# ADDENDUM

**PROJECT: Clovis Landmark Square  
Senior Activity Center and Transit Center**

**ADDENDUM#: 02**

**PUBLISHED DATE: October 30, 2020**

PROJECT NUMBER: 2016-39  
SHEET NUMBER: AD2-E101

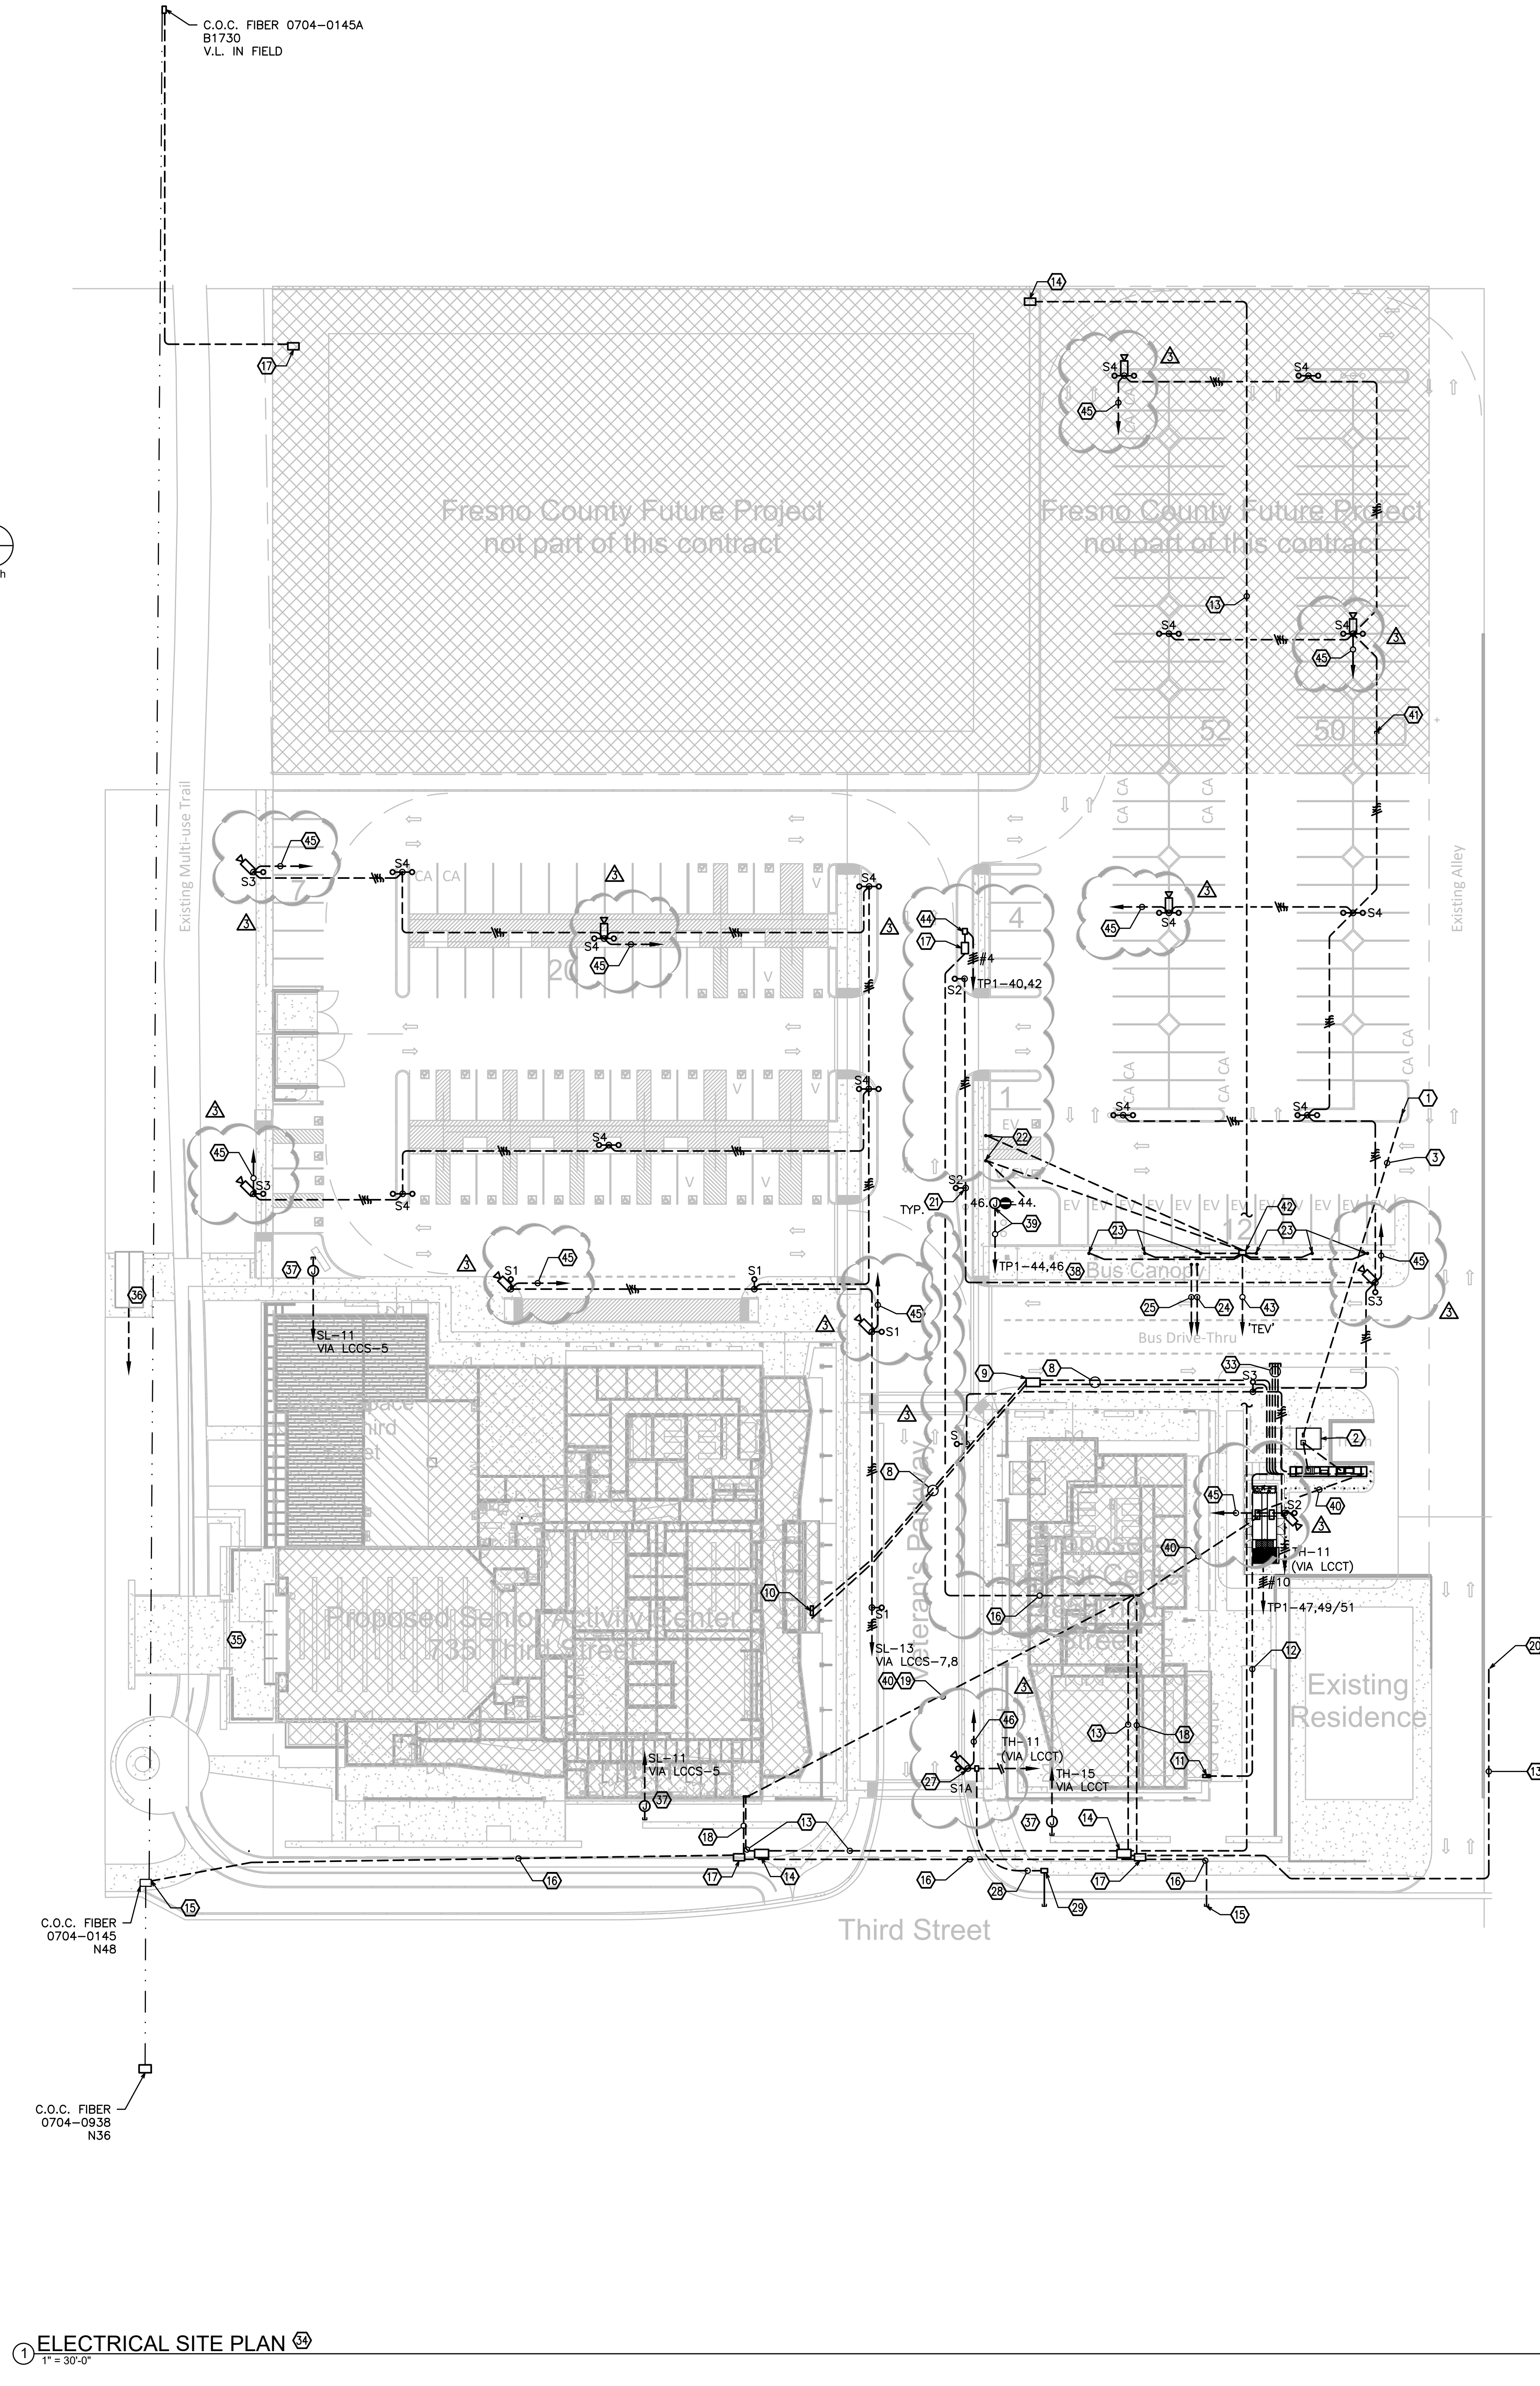
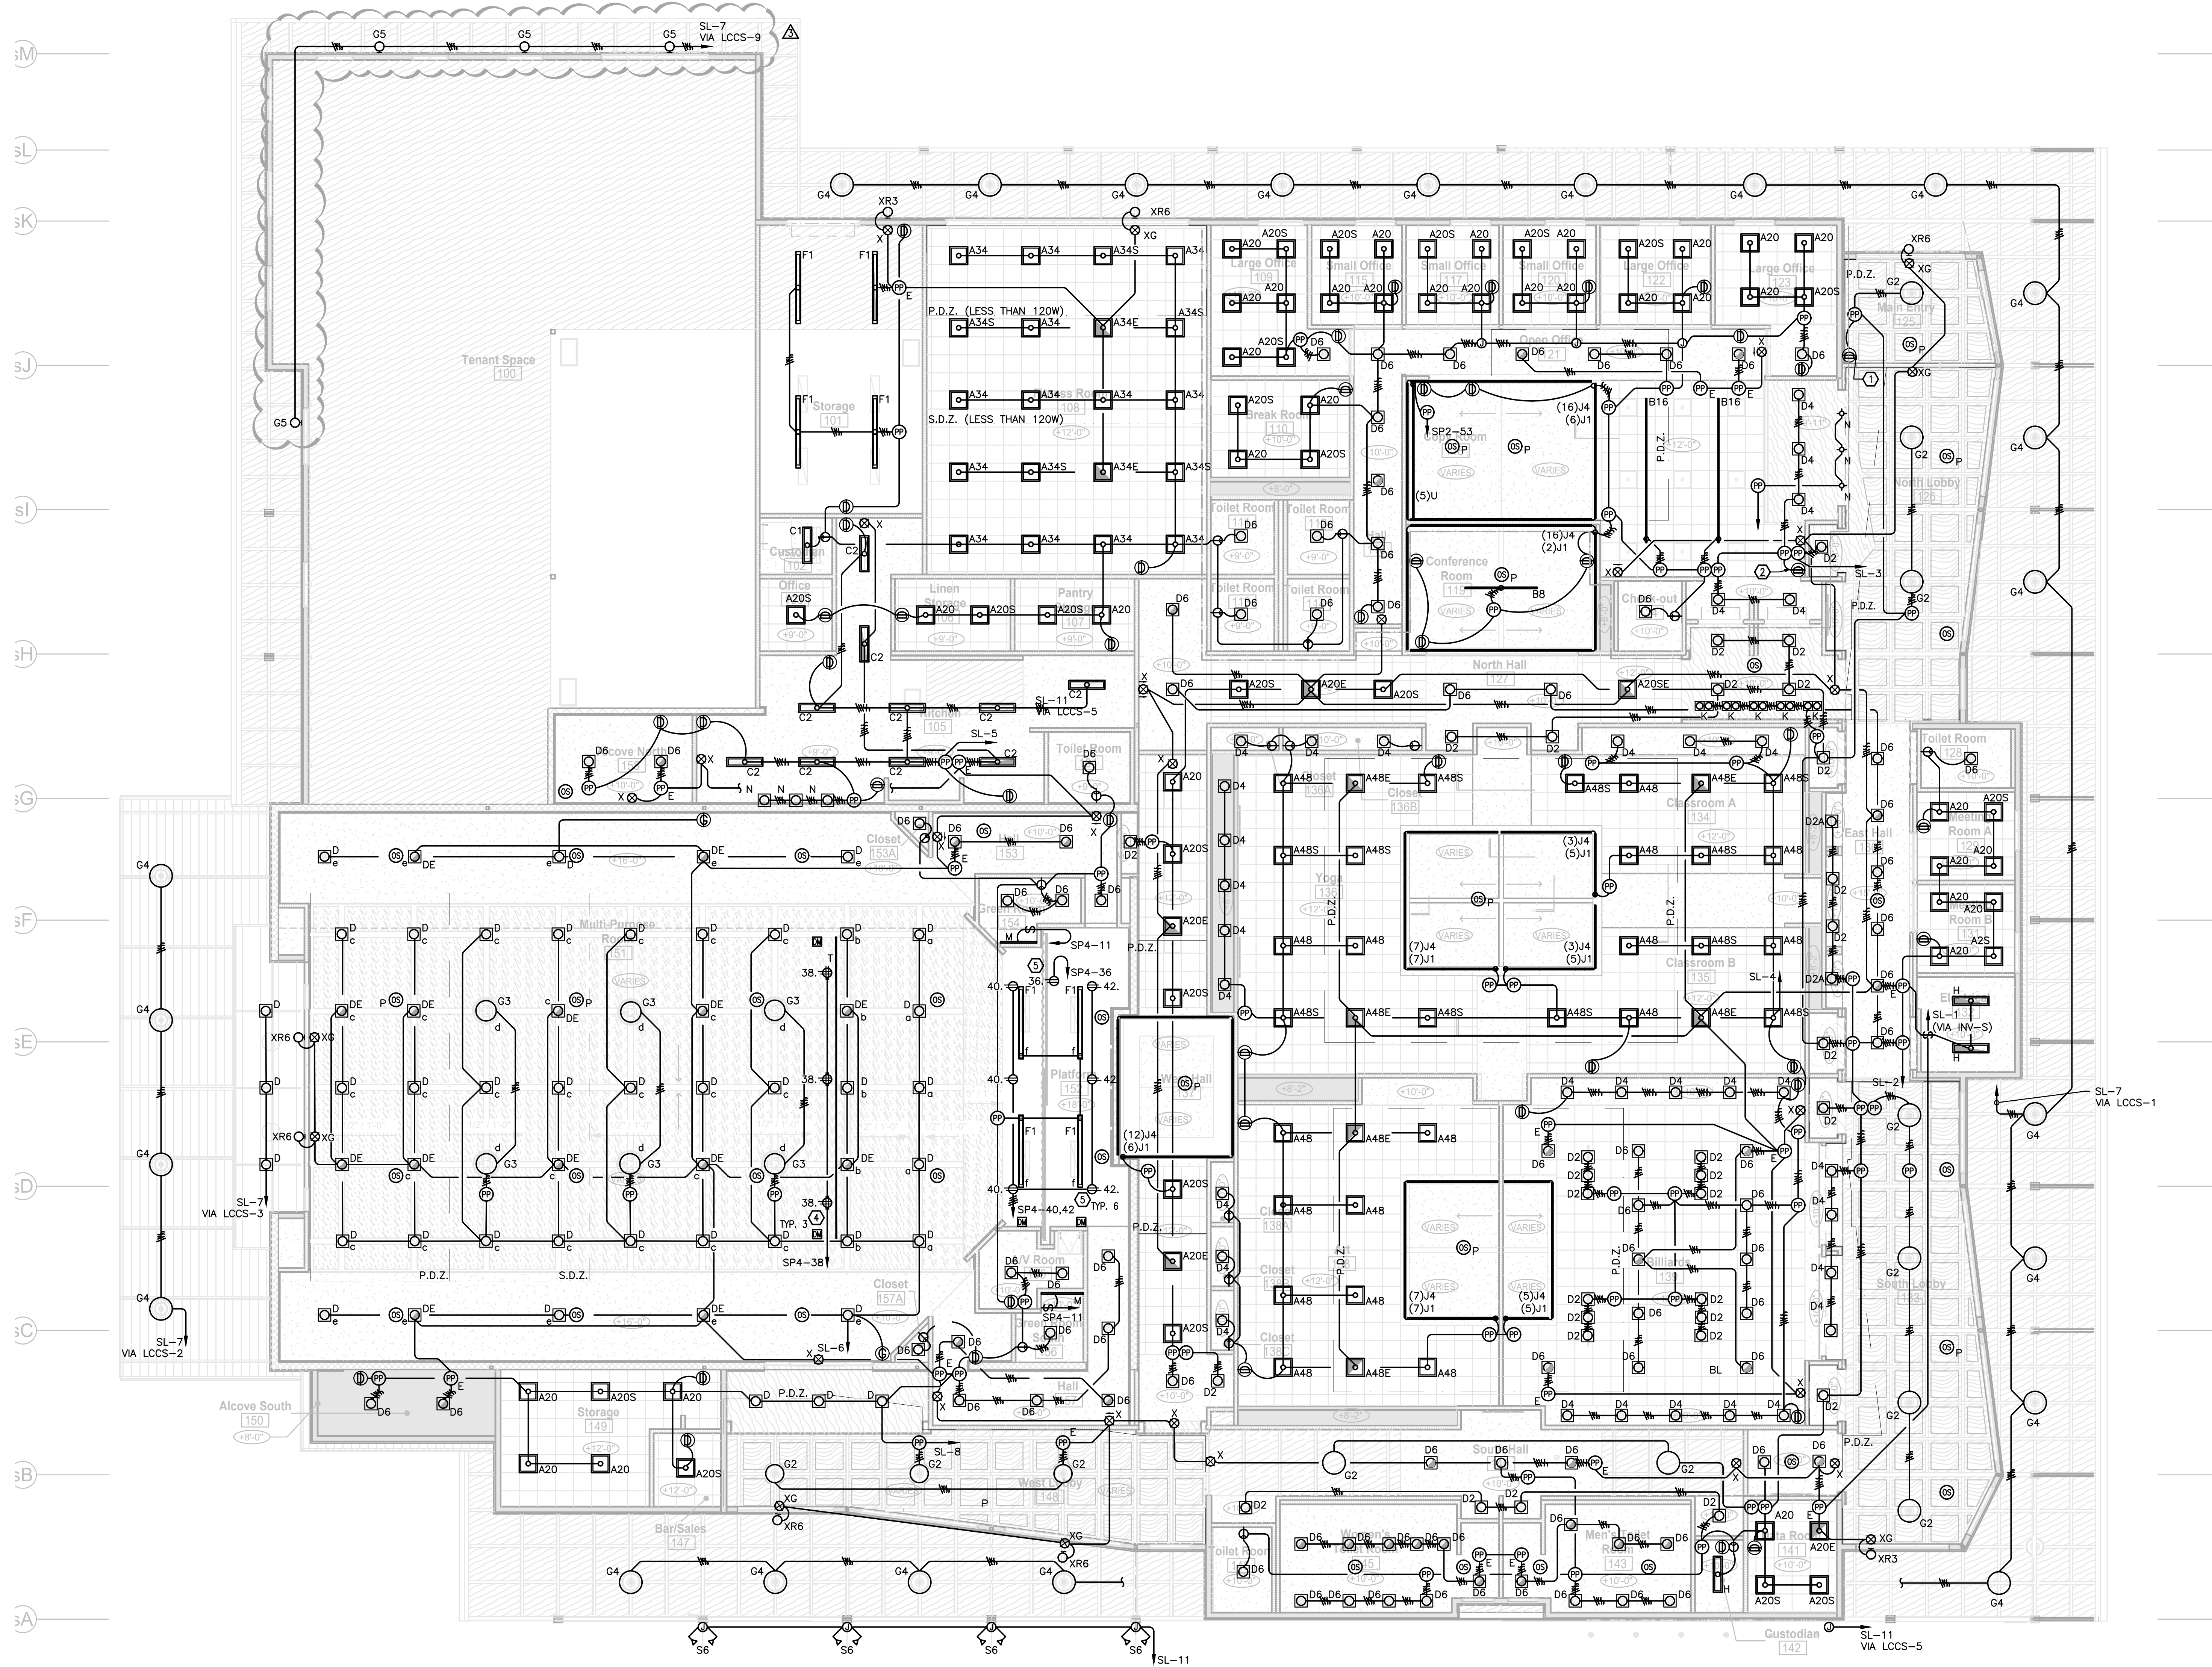
- a. Omit sheet **AD1-E101, Electrical Site Plan** and replace with **AD2-E101, Electrical Site Plan** attached.
- b. Refer to Keynote 41: Contractor to provide all poles, lights, etc. as shown on the drawings including the (4) 'S4' Poles. Contractor to provide them to the Owner for future project.
